Office Action Summary	Application No.		Applicant(s)	
	09/437,296		YAMAJI ET AL.	
	Examiner		Art Unit	
	Aaron M. Dunwoody		3679

Claim 1 is rejected under 35 U.S.C. 103(a) as being unpatentable over US patent 5967489, Nakazawa et al in view of US patent 5058935, Eidsmore.

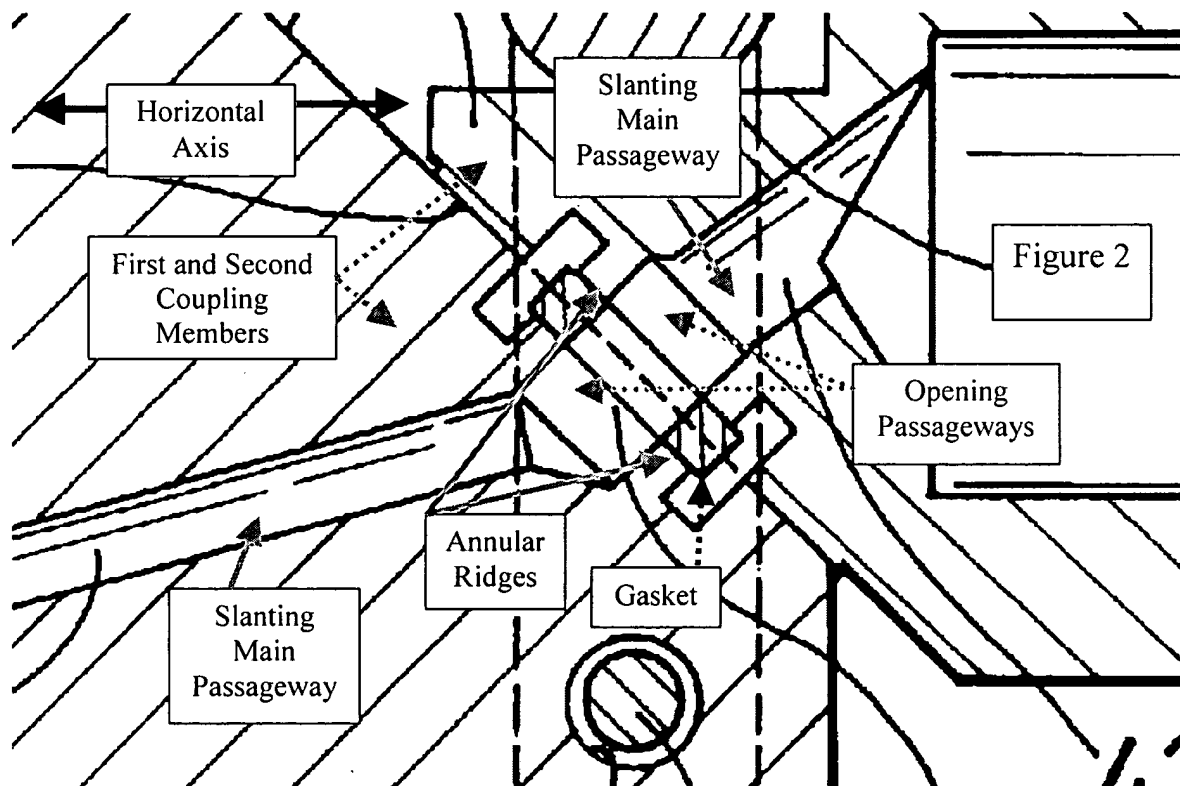
In regards to claim 1, in figure 2 below, Nakazawa et al discloses a fluid coupling comprising first and second coupling members having respective gasket holding annular ridges on butting end faces thereof; and

an annular gasket interposed between the first and second coupling members, wherein each coupling member has a fluid channel comprising an opening passageway orthogonal to the butting end face thereof, and a slanting main passageway

communicating therewith, the opening passageway having a diameter equal to the inside diameter of the gasket holding annular ridge, and

the gasket holding annular ridges are in contact with the gasket at its radial midportion so as (capable) to relieve the inner peripheral portion of the gasket from stress concentration and wrinkles.

Nakazawa et al does not disclose the gasket holding annular ridges being rounded as to be in contact with flat, non-inclined faces of the gasket only at its radial midpoint. In Figure 5, Eidsmore teaches a gasket holding annular ridges (40) being rounded as to be in contact with flat, non-inclined faces of the gasket (42) only at its radial midpoint because this a relatively conventional arrangement well known in the art (col. 4, lines 24-26). As Eidsmore relates to pipe joints employing a metal gasket, it would have been

obvious to one having ordinary skill in the art the time the invention was made to fabricate rounded gasket holding annular ridges as to be in contact with flat, non-inclined faces of the gasket only at its radial midpoint because this a relatively conventional arrangement well known in the art, as taught by Eidsmore.
